2019/0747/FUL for the construction of a mushroom farm at address: Bungalow Farm, Heaton's Bridge Road, Scarisbrick, West Lancashire, L40 8JQ

Appendix 1.0 Landscape and Visual Impact Appraisal – Critical Review

Extracts 1 Before and After showing in plan view the red site boundary and key trees (green) and woodland (blue)

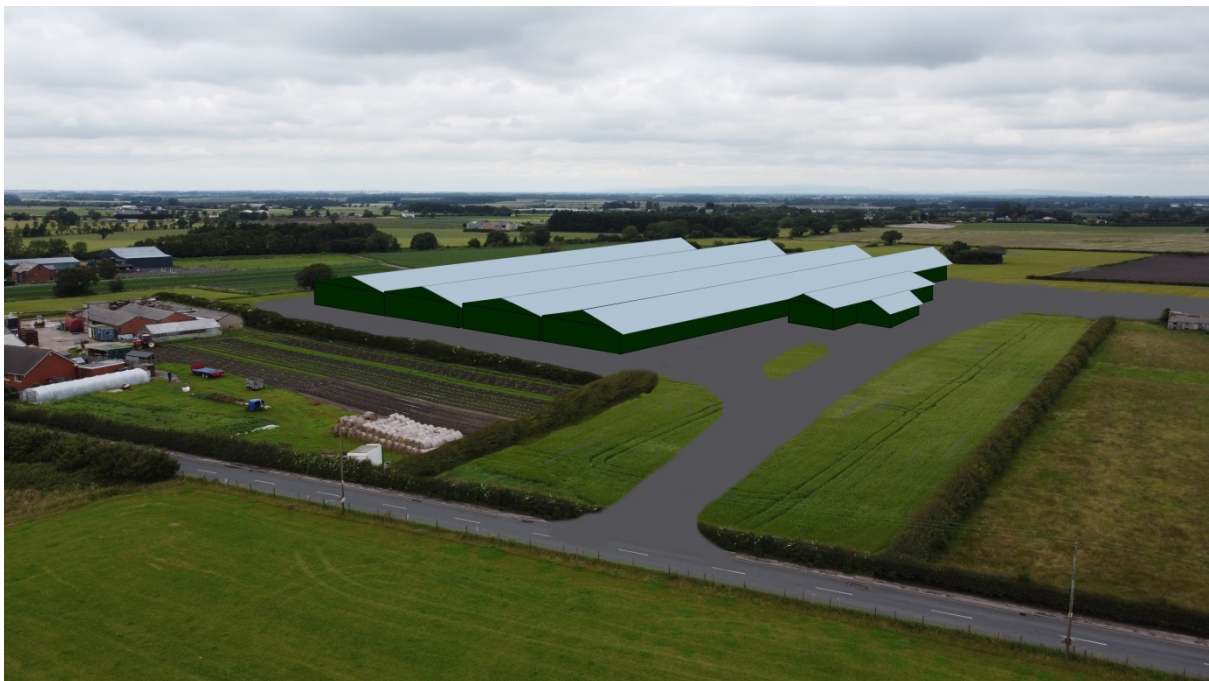
24. I agree that the site, (postcode L40 8JQ) marked in red on Extract 1 below, is currently open crop-rotation fields.

30. The cluster of buildings at Bungalow Farm to the west of the site is visible. You can see a lone tree on the northwest boundary, and four trees spaced along the north east boundary (green) and two clumps of woodland to the north (blue) that are situated 0.5km distance to the north side of the Leeds-Liverpool Canal. When stood outside the field gate on Heaton's Bridge Road facing north you can see the metal seven bar gate that secures the field and the hedgerow. The field topography is flat so you not only see the trees spaced along the field boundary (green), and beyond these the clumps of woodland (blue).

After Image

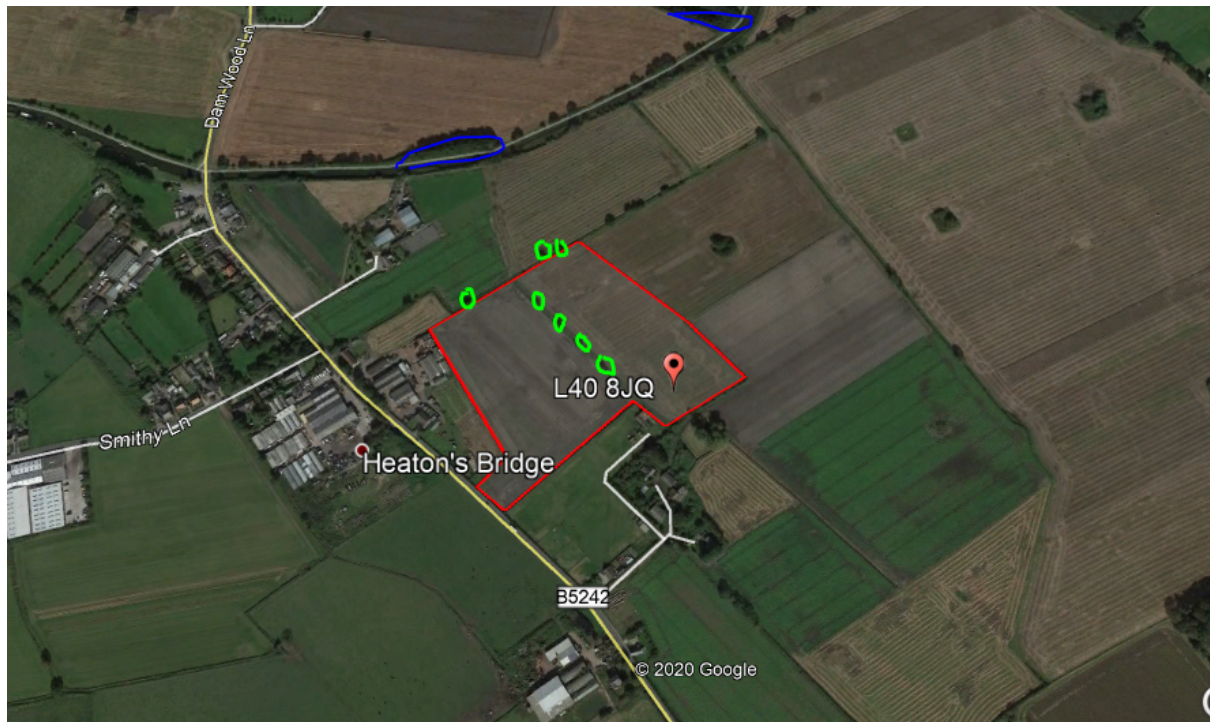
25. What stands out in particular is that there are no illustrations that show the true scale and mass of the development in situ, and therefore the full impact is impossible to understand fully. For example, on page 24, Fig 4, sets out the dimensions for the boiler room, office/plant room, incubation rooms, growing rooms, packing areas, and covered corridors in a tabular format, rather than helpfully providing the elevations or plan illustrations showing the development in locational context. From calculation, the building would dwarf neighbouring buildings, as the ridge of the roof

is up to 7.9 m high in places, and it extends 0.15km in length and 0.145km width. The building is double the scale of the local retail complex. See Appendix 1.0 Extract 3 which compares the scale of the development with the retail site. Below are indicative before and after images to aid understanding of what the impact will be. The Landscape Appraisal is clearly deficient in this regard.

1939 Tithe Maps of area

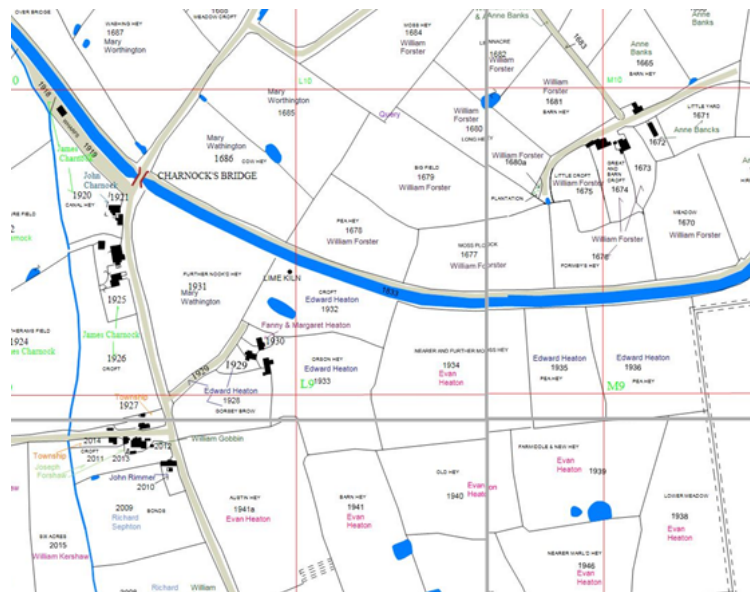
33. I would have expected the Landscape Appraisal to consider the cultural and historical importance of the agricultural landscape more fully. Heaton's Bridge is classified as an area of *Local Landscape History Importance* representing "modern enclosure". This refers to field patterns and other landscape features which date from the mid 1800's. Above are stitched together tithe maps from 1839, which enables comparison of field patterns and landscape features, which shows the link between our heritage and modern day farming. This is an important factor that ought not to be overlooked.
